STAFF REPORT: 04-15-2020 MEETING

APPLICATION NUMBER: 20-6682

ADDRESS: 630 VIRGINIA PARK

SCOPE OF WORK: REMOVE EXISTING REAR WING, ERECT A NEW SMALLER WING, AND REPLACE WINDOWS.

Sheet Title :
**1ST FLOOR
PLAN**

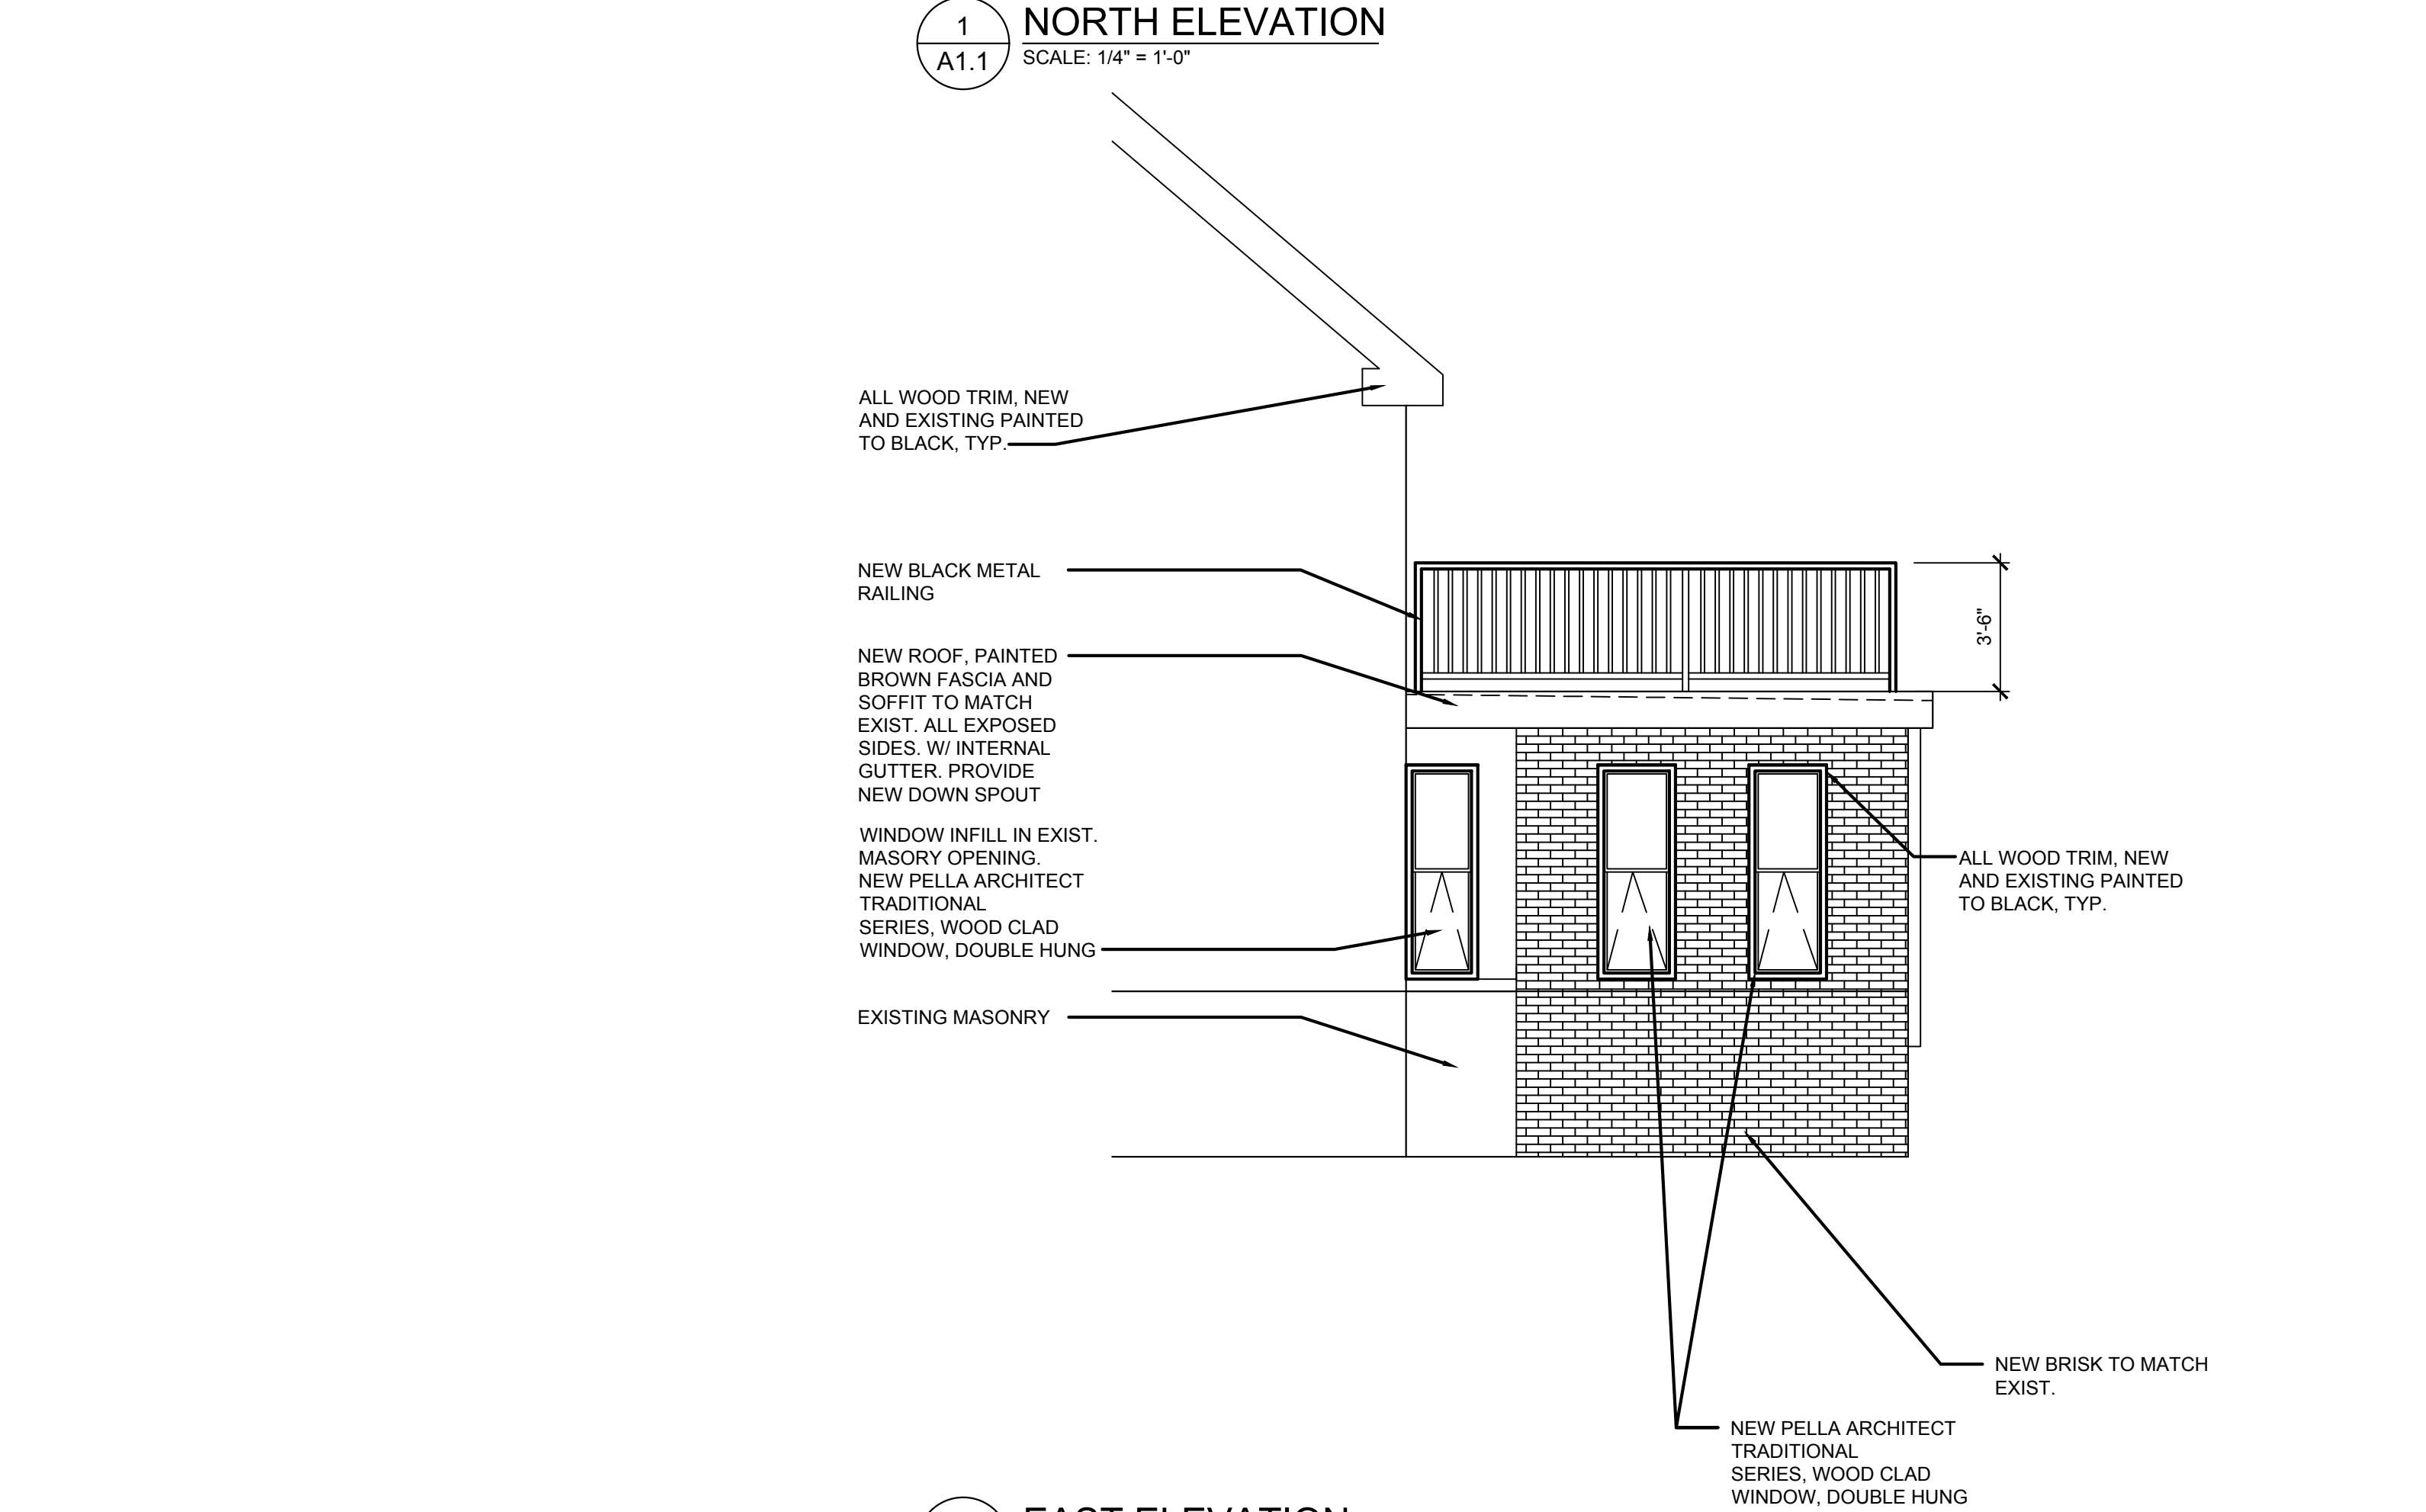
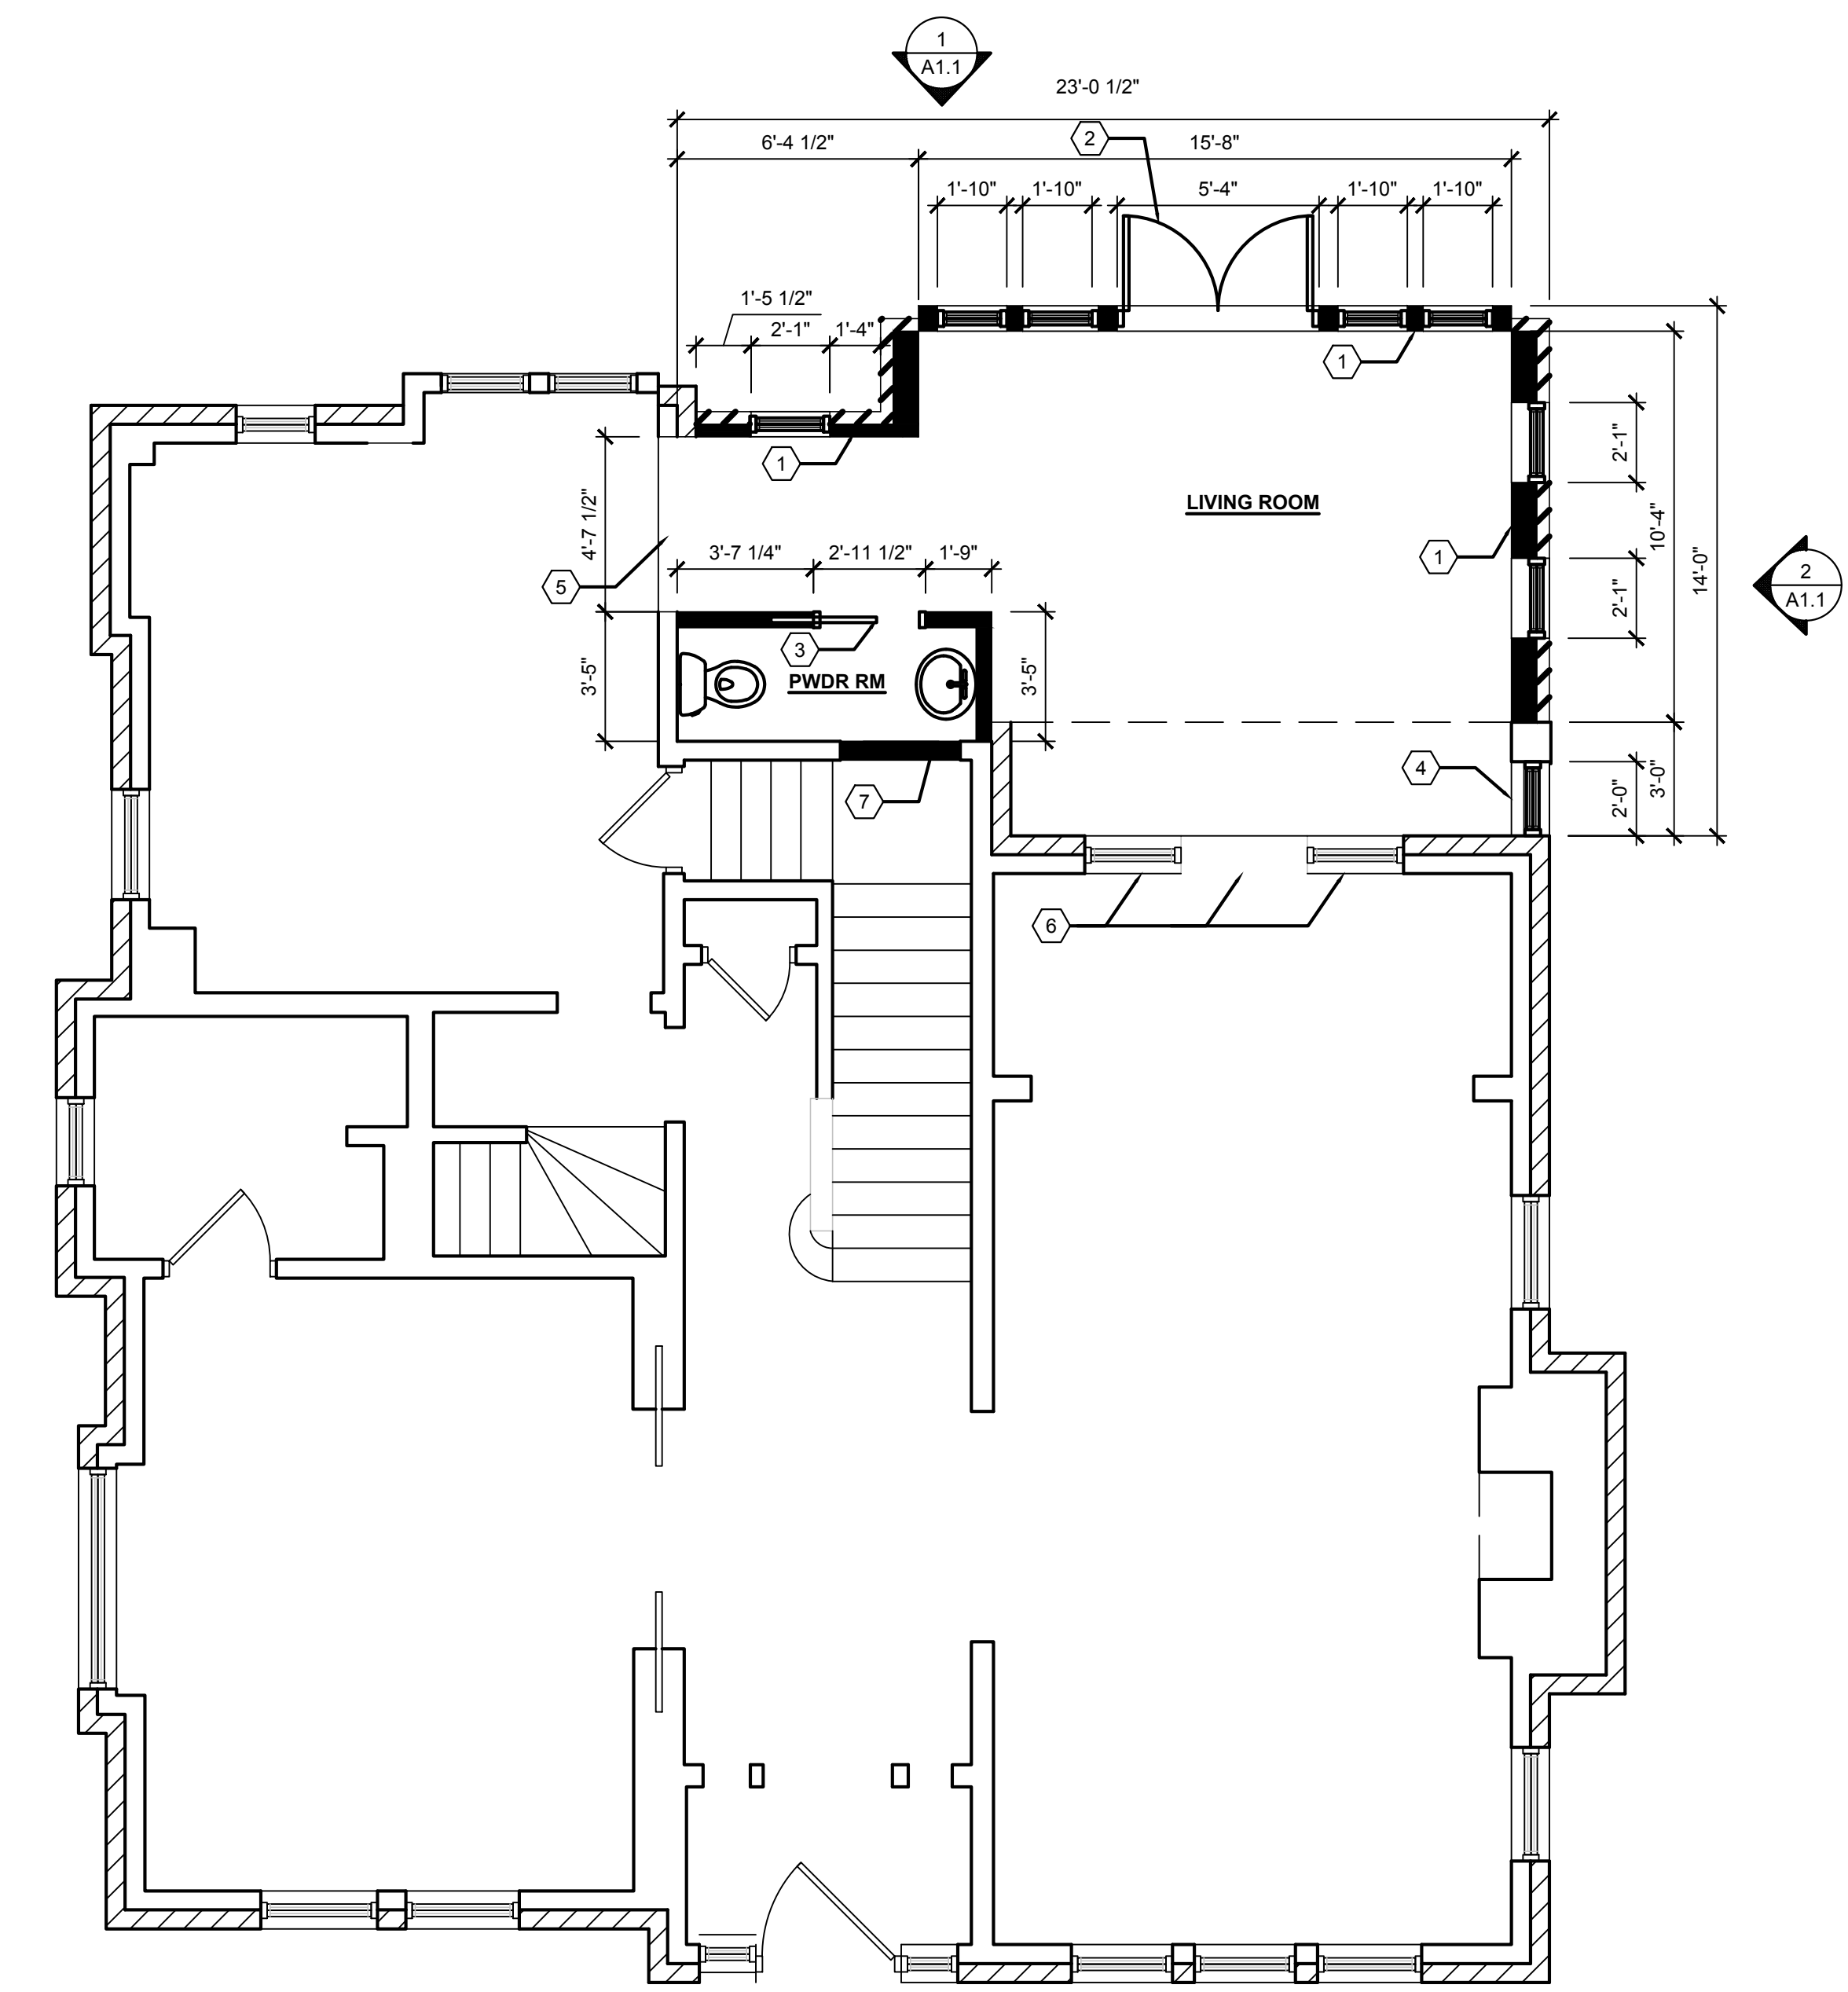
- A “**Small, Walk out deck**” is mentioned in the annotated photos, but size, materiality, and location is not specified in the application. More information is required for staff to understand and recommend approval for this aspect of the proposal.
